## AB1274: Riverpark Gardens, Bromley BR2 0BQ

### Review of Phase 1 Geotechnical Desk Study Report

By: Adrian Boulton  
 BEng (Hons) CEng MIStructE  
 Senior Partner

Date: 26/11/2014

Prepared MS	Date NOV 14	Sketch No.	SK 01	Rev
-------------	-------------	------------	-------	-----

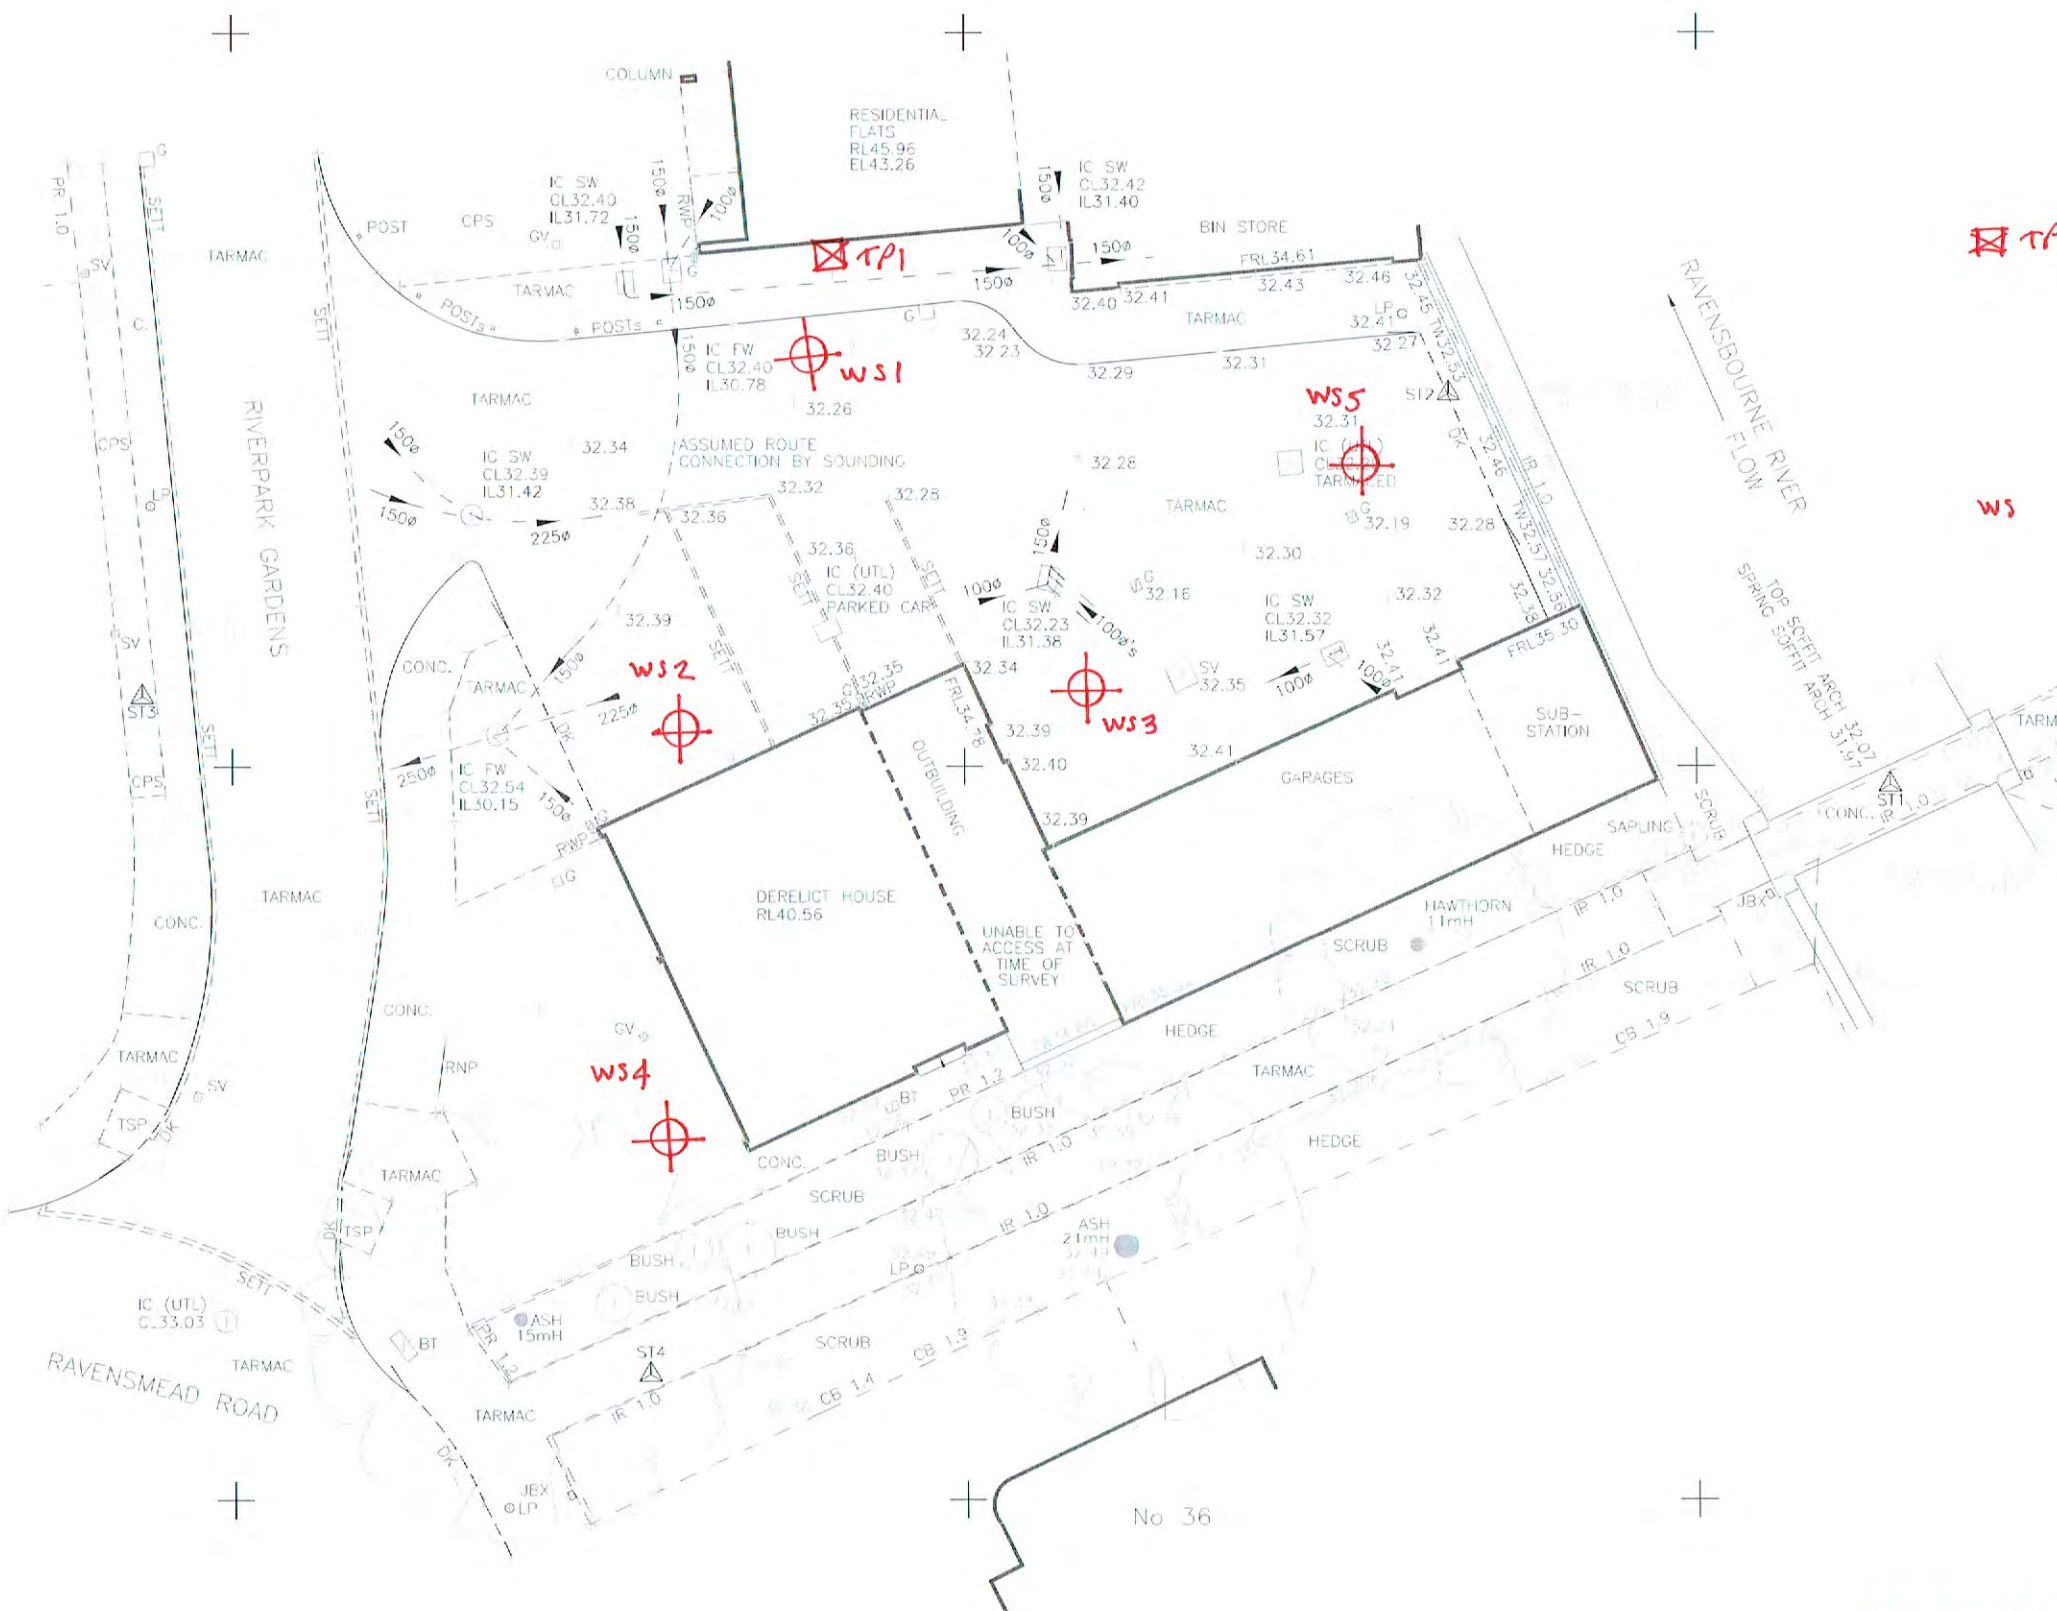
5. A trial pit is needed against the external wall of the existing block of flats immediately to the north of the site to establish the depth and projection of the footing to assist with party wall matters.

8. We recommend as part of the Phase 2 geotechnical investigations to carry out 5 No. window sample (WS) boreholes to approximately 5.0m depth. Locations as shown on the ABSRUCT sketch SK01.

9. Ground gas and water monitoring to be carried out in one of the WS.
10. Contamination testing is to be carried out on 5 soil samples from the WS holes for a screening suite of contaminants. The analytical suite would include total petroleum hydrocarbons (TPH), mineral oils, metals, polyaromatic hydrocarbons (PAH), soil organic matter, water soluble sulphate and pH, asbestos and arsenic.
